DESIGN OVERLAY ZONE AMENDMENTS

VOLUME 2 | CODE & MAP AMENDMENTS

Recommended Draft - *As Amended*
June 2021

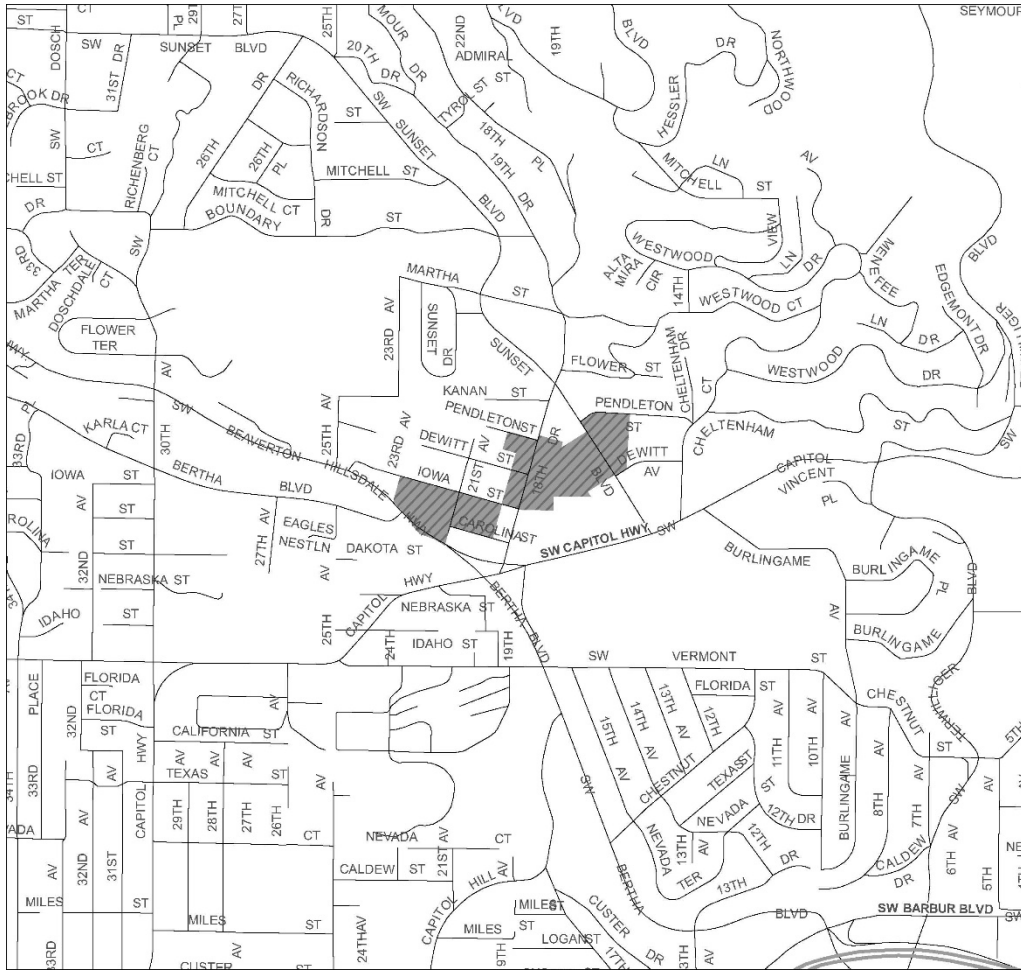
The following map shows the changes proposed in the Hillsdale area. This removes the 'd' overlay from R2.5 zones that were part of the Hillsdale plan district. The zoning in this plan district was implemented before the city had created any design standards for single dwelling development in these zones.

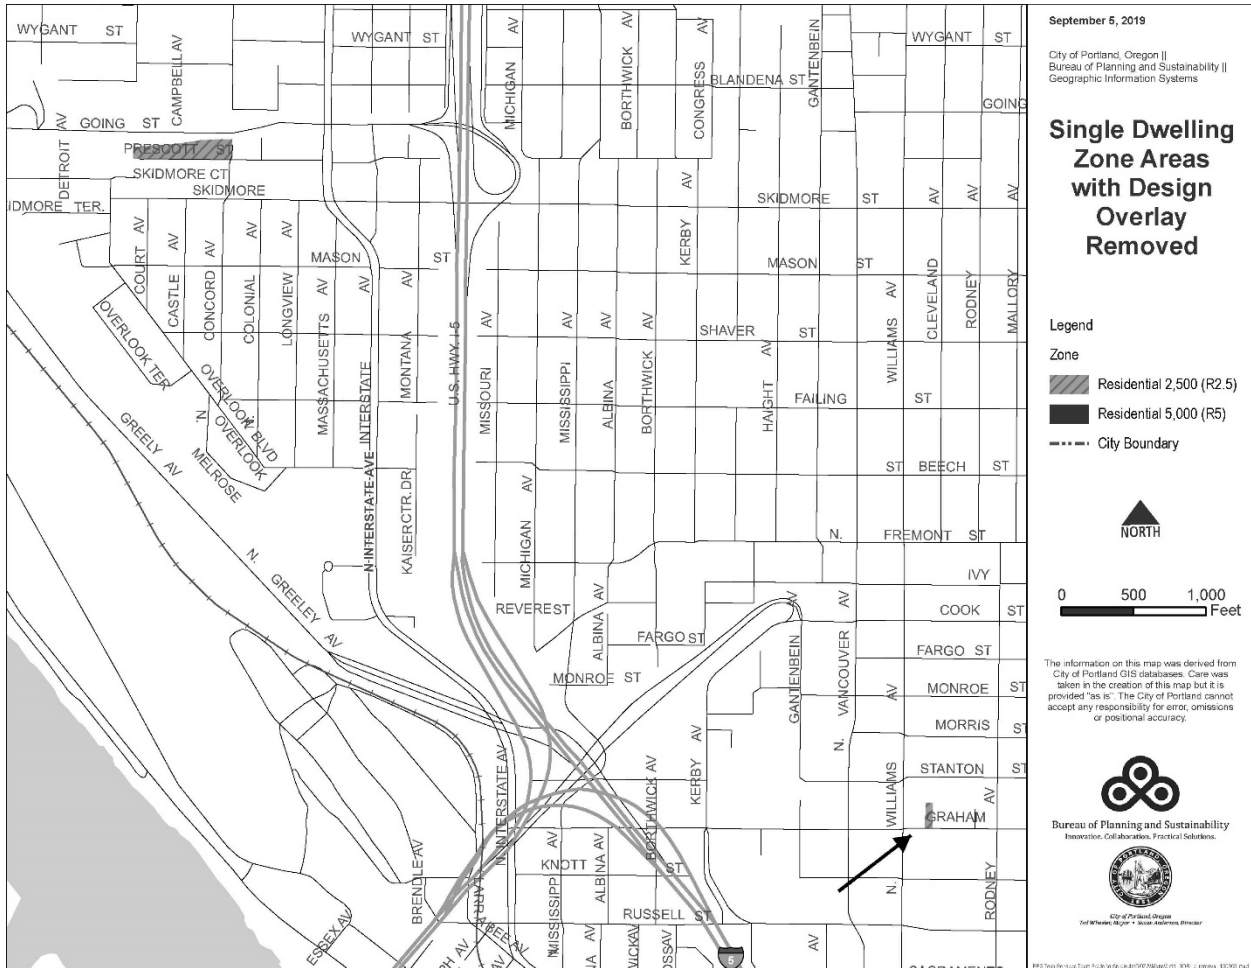
The following map shows the changes proposed in North Portland area. This removes the 'd' overlay from R2.5 zones along a block of North Prescott west of Interstate that are part of the North Interstate plan district. This plan district includes special compatibility standards for all R2.5 zones that borrow from current Community Design Standards. These plan district standards are sufficient and the new design standards are not created to regulate small scale residential.

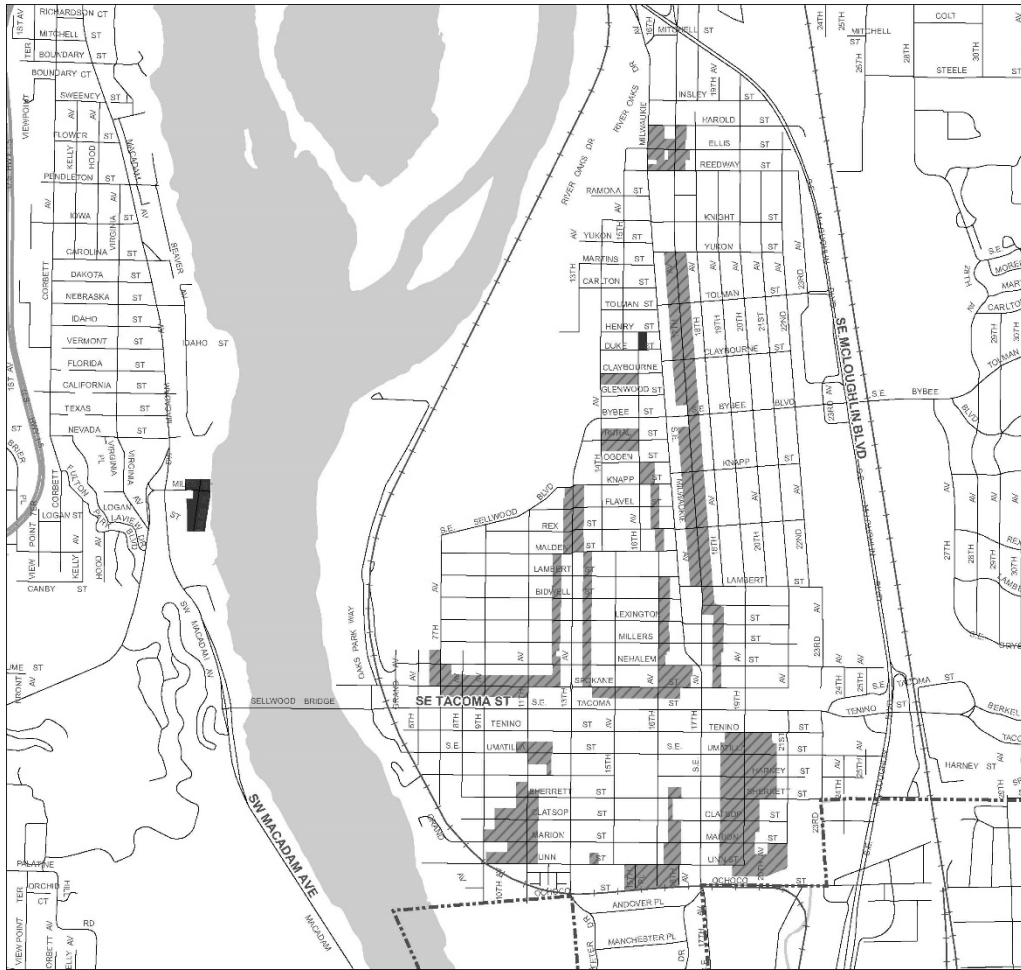
The following map shows the changes proposed in the Sellwood/Westmoreland area. This removes the 'd' overlay from R2.5 zones that were part of the Sellwood/Westmoreland neighborhood plan. The zoning resulting from this plan was implemented before the city had created any design standards for single dwelling development in these zones.

There is also an R5 area on the west side of the Willamette south of Willamette Park known as Miles Place. This area is an eclectic area that originally consisted of houseboats but is now more permanent homes. The area has several other issues that affect development including the Greenway overlay zone and flood plain and is part of the Macadam plan district. The overlay created as part of this district pre-dates any single dwelling design standards that are now in the base zone. The new design standards were not created to further regulate small scale residential development.
